Joint Research Centre

JRC Opinion on vibration test procedure and profile

January 2021

Japan test data* (Real number plot)

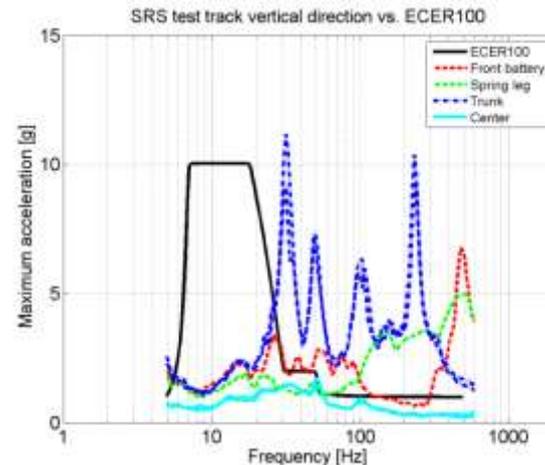
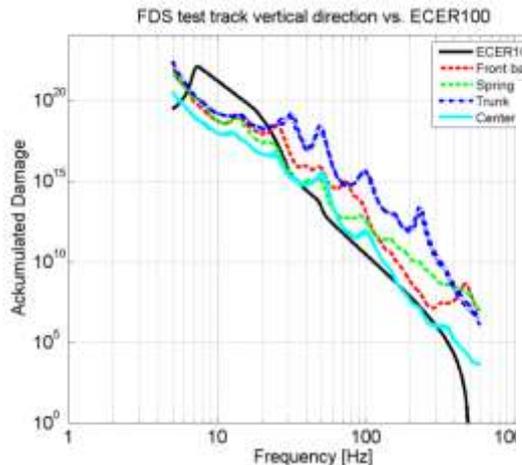
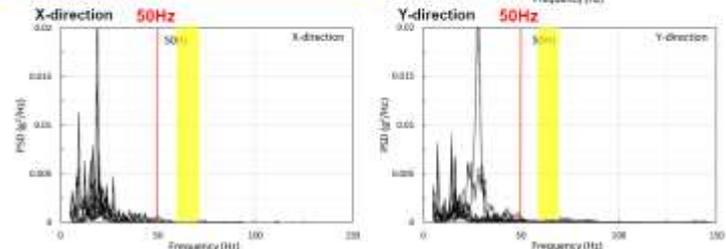
- Vibration at around 70Hz exists.
- REESS resonant frequency is about from 60Hz to 70Hz according to China test data.

Justification to limit the vibration test frequency below 50Hz is not sufficient.

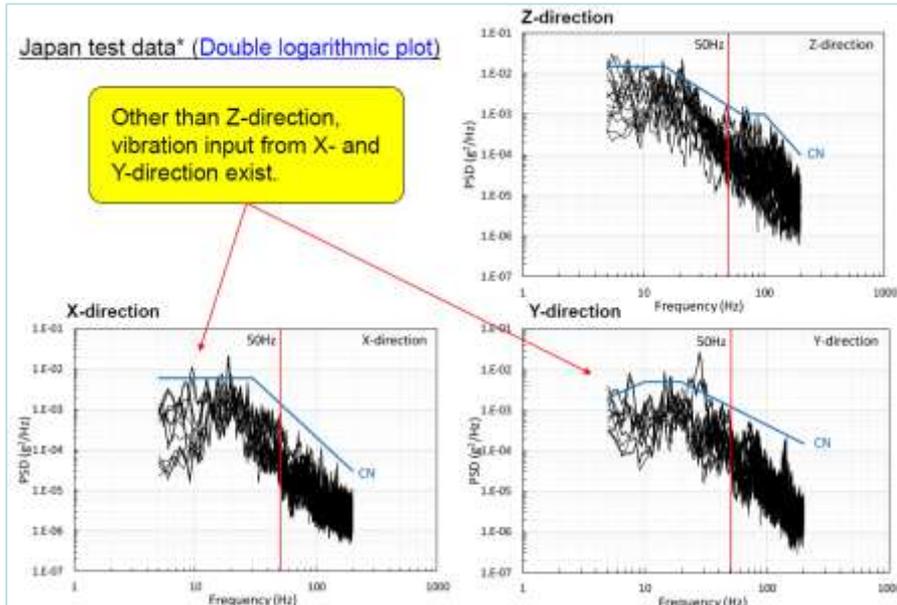
ECE R100 (and GTR 20) test is only more severe than real service if the resonance frequencies of the test object is between 5 and 20Hz.

Japan test data and comments on REESS Vibration (Adopted from "EVS18-E2VP-0100 [JP]Japan comments on REESS Vibration Test.pdf"; Tokyo, 6/2019)

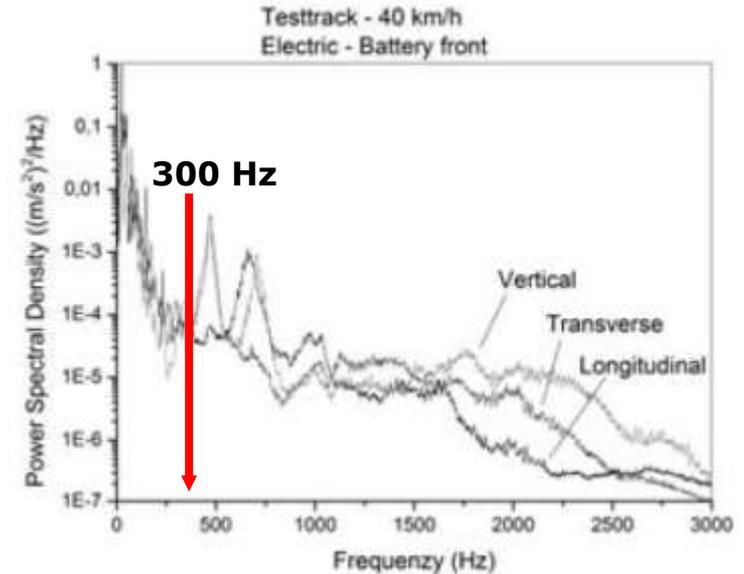
No comparable PSD values above 300 Hz in all 3 directions.

Vibration loads in x- and y-directions are almost 50-70% of the ones in z-direction, suggesting vibration test in 3 directions makes sense

Japan test data: PSD vs. frequency plots
(Adopted from "EVS18-E2VP-0100 [JP]Japan comments on REESS
Vibration Test.pdf"; Tokyo, 6/2019)

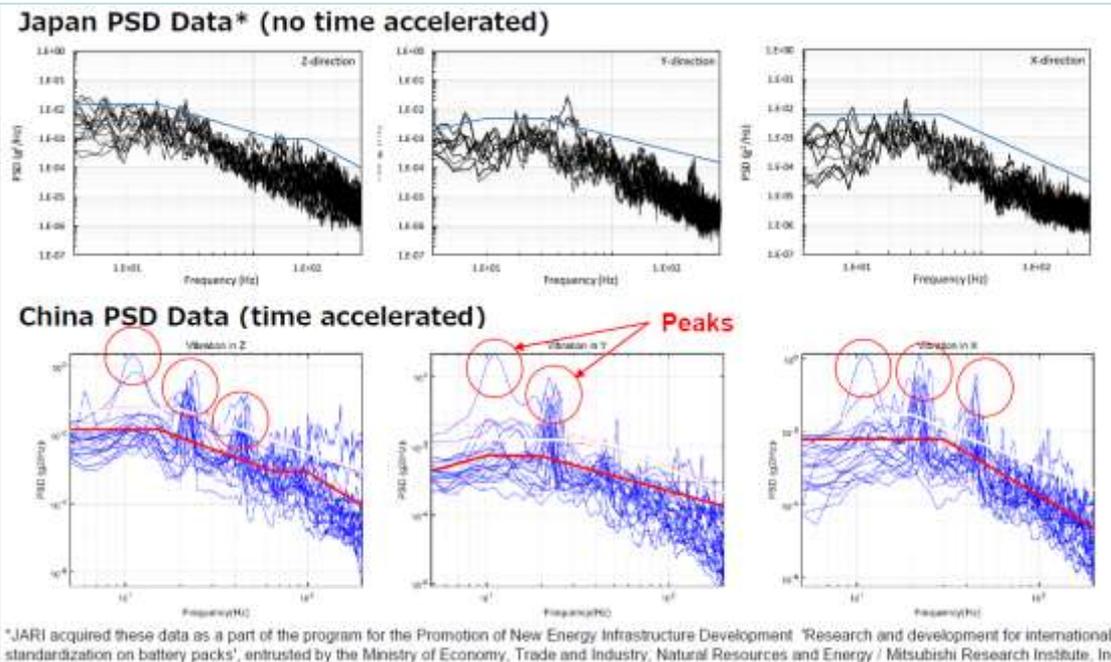
Resonance peaks at different frequencies in different directions can be seen, suggesting vibration test in 3 directions makes sense
